HP MODEL 8566A SPECTRUM ANALYZER**IF Section Serial Prefix 1928A and Below****MODIFICATION TO IMPROVE MAGNETIC SUSCEPTIBILITY OF DISPLAY**

This Service Note documents adding a Mu-Metal shield over the CRT in older IF sections. The effect is to decrease the magnetic susceptibility which appears as random movement of the trace on the CRT. This may occur when an instrument which radiates strong magnetic fields (such as a calculator, sweeper, etc.) is placed near the CRT of the 8566A.

Figure 1.

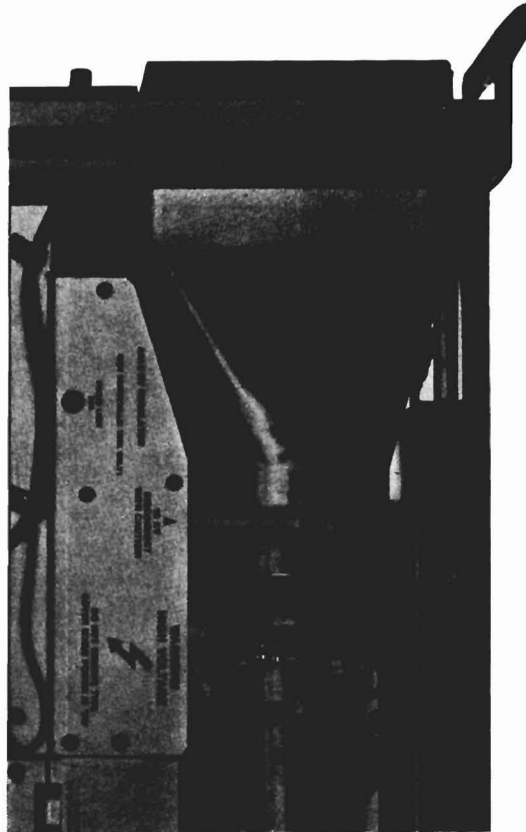
7. Insert the CRT part way into the mainframe and fit the front panel Bezel onto the shield. The fit is quite tight but the CRT and shield must push completely into the Bezel.
8. Finish the installation according to the instructions in the Operating and Service Manual, Figures 8-7 and 8-8. See Figure 1.
9. Verify that the trace align and trace orthogonality are acceptable. If not, make adjustments as outlined under step 5 of this procedure.
